## CLIENT NAME: OYU TOLGOI LLC

## PROJECT NAME: Oyu Tolgoi Underground Project Rev\_1

R	EQUEST FOR I	NFORMATION	(RFI)		
TO:	Jacobs			DATE:	09-03-	2022
FROM: PHONE #:	MCS International LI	LC		RFI No: REV #	TWS-0	)414-RFI-0057
FIIONL#.	+976-77226262			KLV#	0	
SUBJECT: 1	883: Edge of 1883-W	VSS-2001 ins	tallation hole	•	<u> </u>	
Refer	ence Document No.	Rev No.		Ti	tle	
	1883-15-L4-1115	1	TRUCK SHOP HAULAGE LEVEL – WASH BAY CONCRETE – PLAN, SECTION AND DETAILS			
1883-55-L4-8320		2	CHASSIS SPRAY FRAME/ CHANNEL DETAIL			NEL DETAIL
1883-55-L4-8294		2	MAIN FRAME – CHASSIS SPINNER		PINNER	
Discipline C	odes (Mandatory) D	01 (CSA) - 🖂	<b>D2</b> (MP) -	<b>D3</b> (E8	kl) - 🔲	<b>D4</b> (Other) -
made with eq equipment in: There provide detail	On drawing 1883-15-R1 jual angle L03, plate 6x stallation hole is made v efore, the contractor rec on how the works show erequested RFI applies only to this reques	32 and stud. Or with equal angle quests the compuld be done.	n drawing 1883 e L02. In attach pany to clear di	3-55-L4-8320 nment 1.	The edg	e of washer

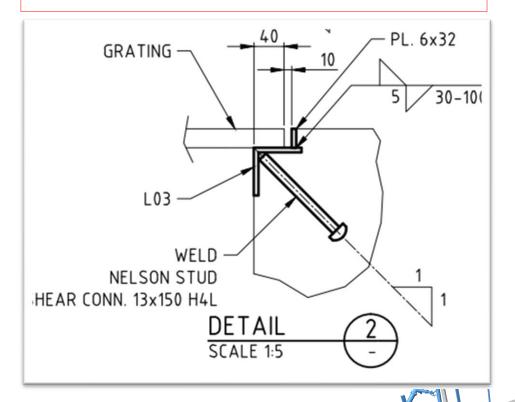
On drawing 1883-15-R1-1115, The edge of grating and washer equipment installation hole is made with equal angle L03, plate 6x32 and stud.

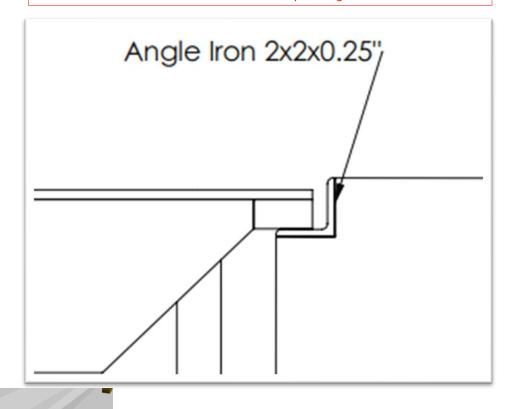
On drawing 1883-55-L4-8320, The edge of washer equipment installation hole is made with equal angle L02.

DWG NO.
8.0B-1883-WSS-2001 D9.00

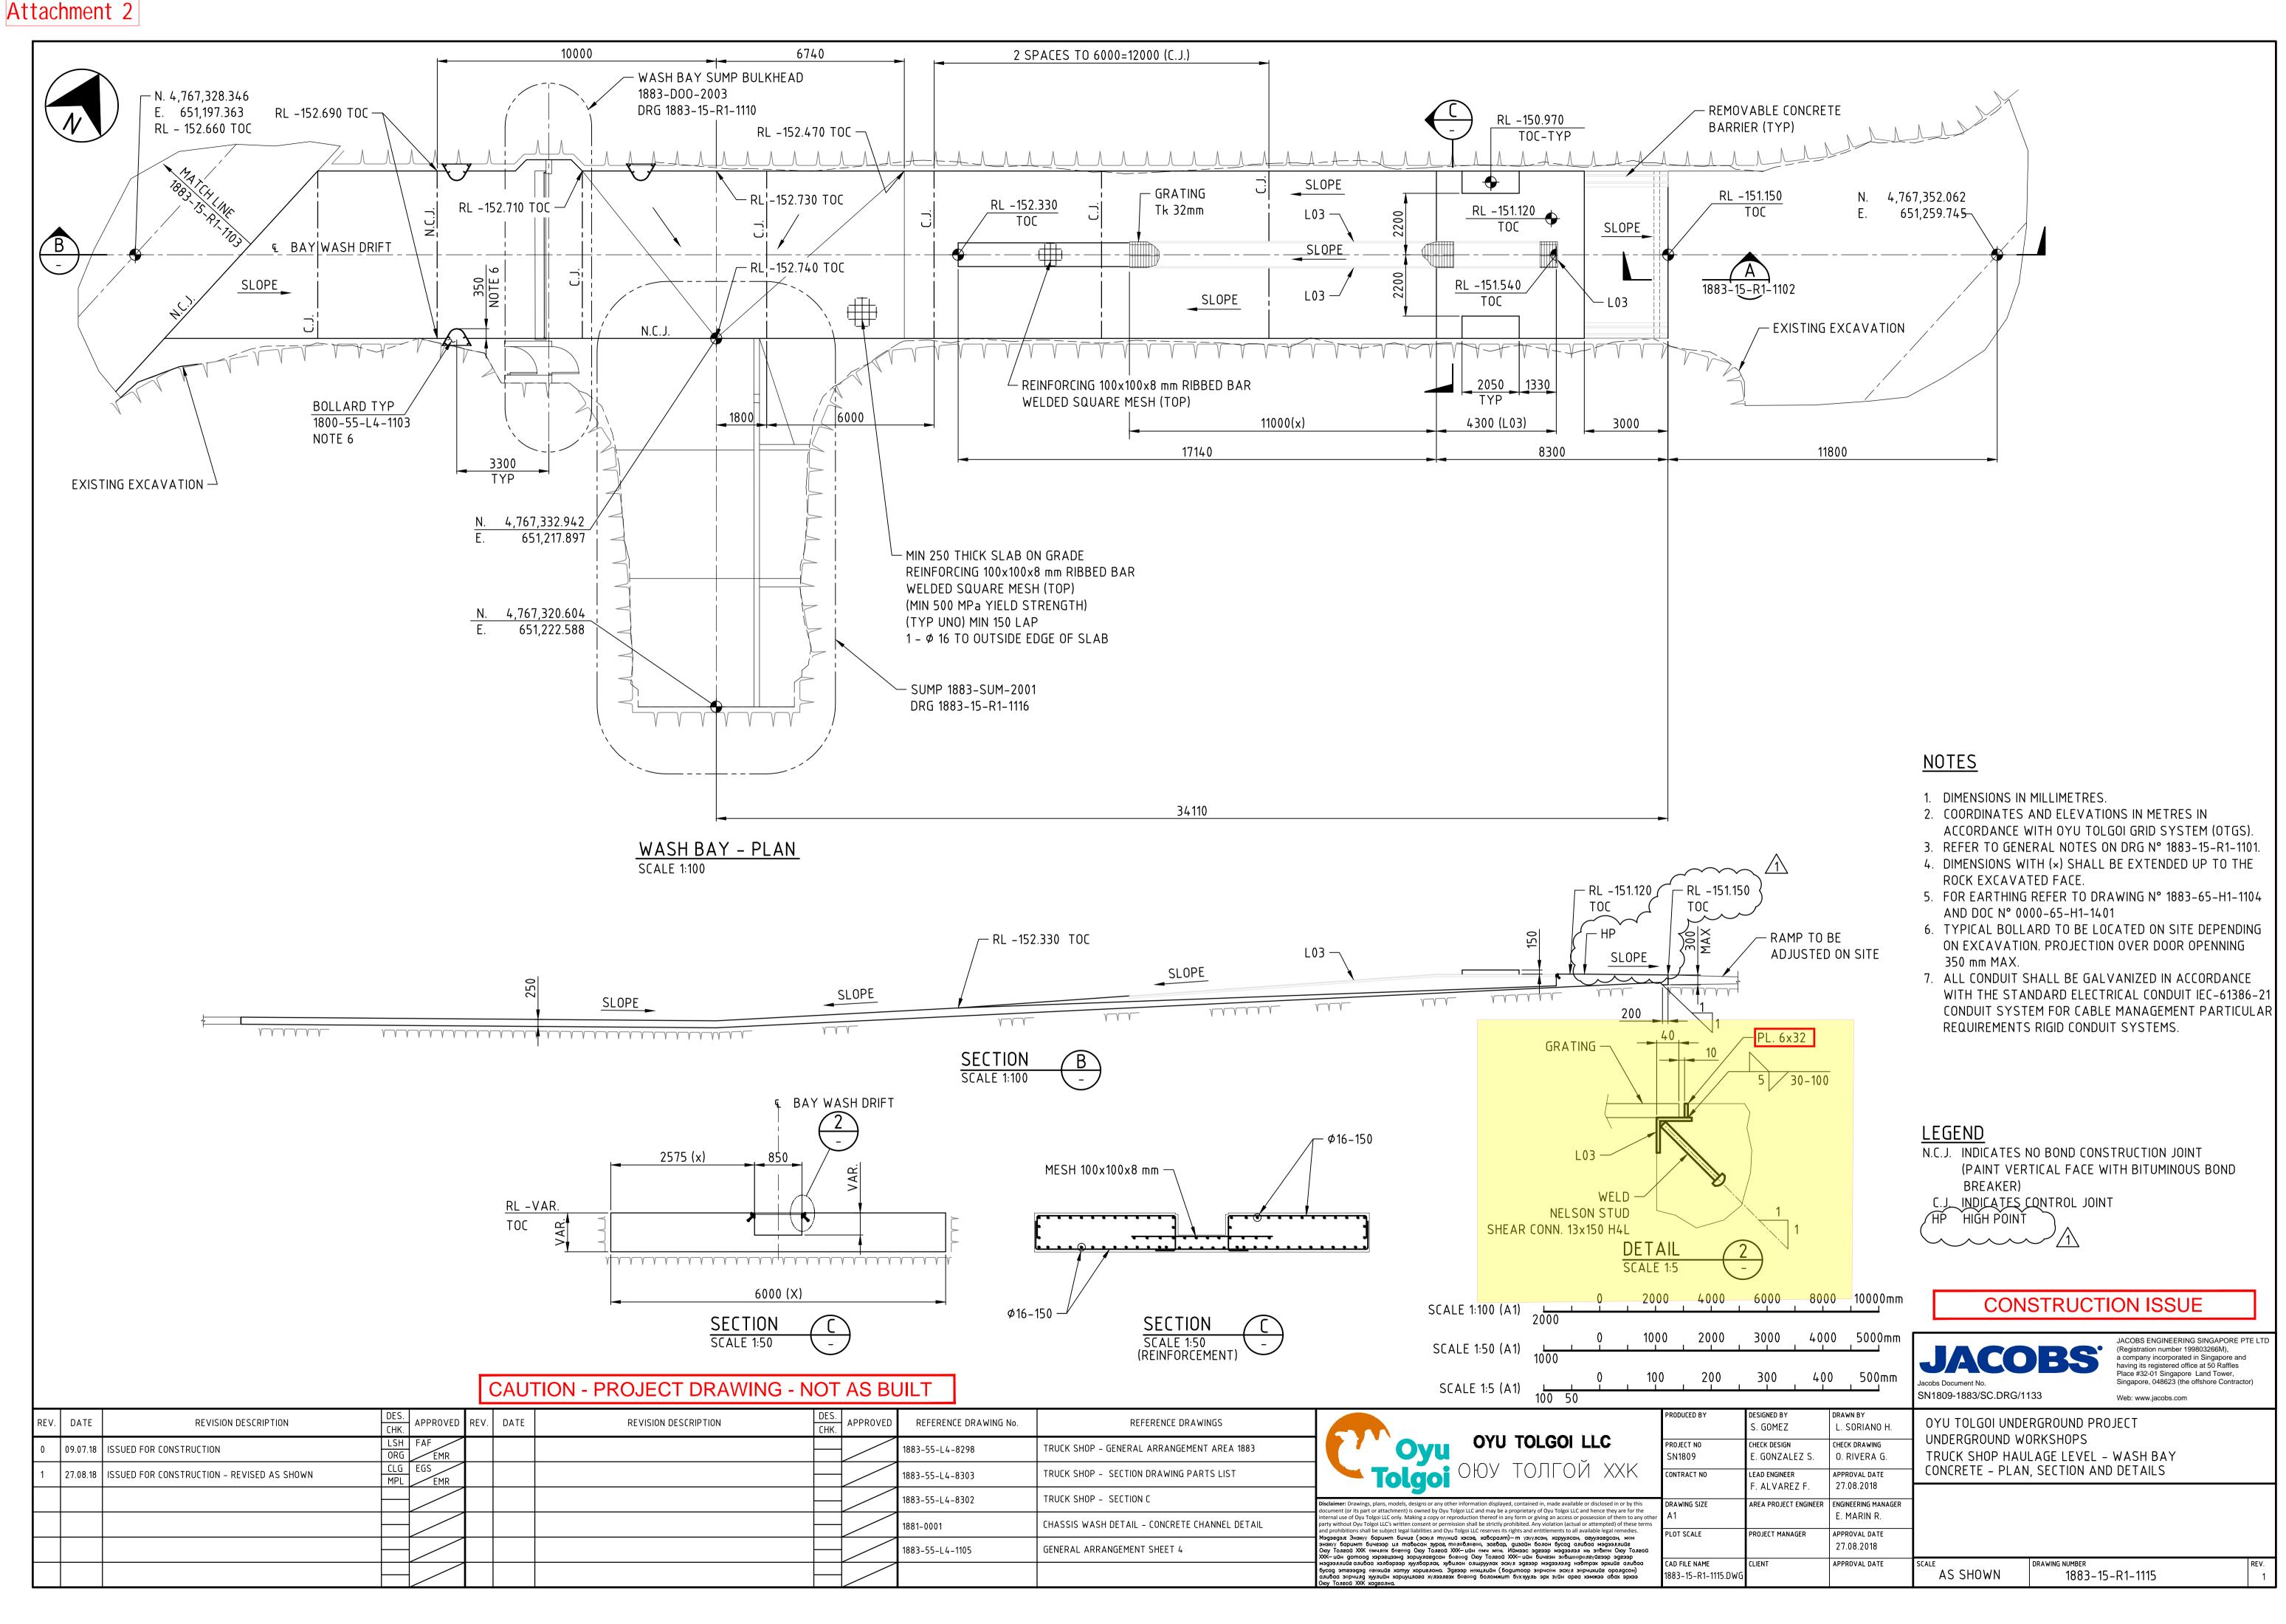
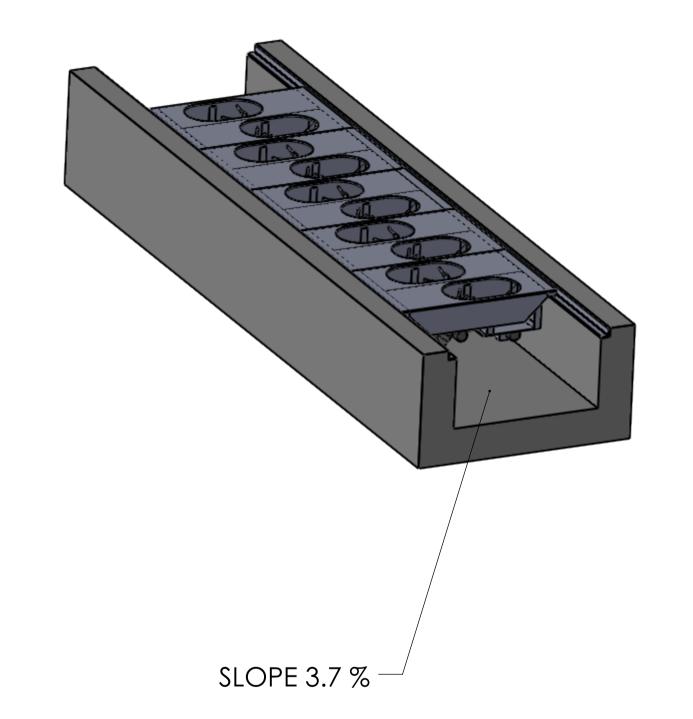
## Attachment 3 Angle iron 2/2/0.25;
